URGENT Field Safety Notification

HeartStart Intrepid Monitor/Defibrillator (867172)
Service Manual Electrical Safety Test Issue

10-OCT-2023

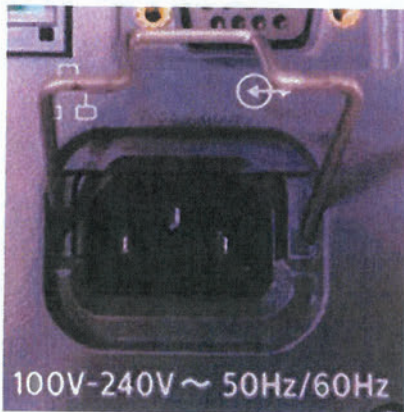
A Class I HeartStart Intrepid power supply can be identified by having a three-pin power socket and via the label on the bottom of the device.

A three-pin power socket will be visible on Class I HeartStart Intrepids as shown below:

- If you have a Class I device that has been opened and serviced, test your HeartStart Intrepid device(s) using the attached Service Manual Addendum.
- A hard copy of the Service Manual Addendum is included with this notification. A copy should be kept with each HeartStart Intrepid Service Manual. If you use a CD version of the Service Manual, ensure that the additional instructions from the hard copy are followed.
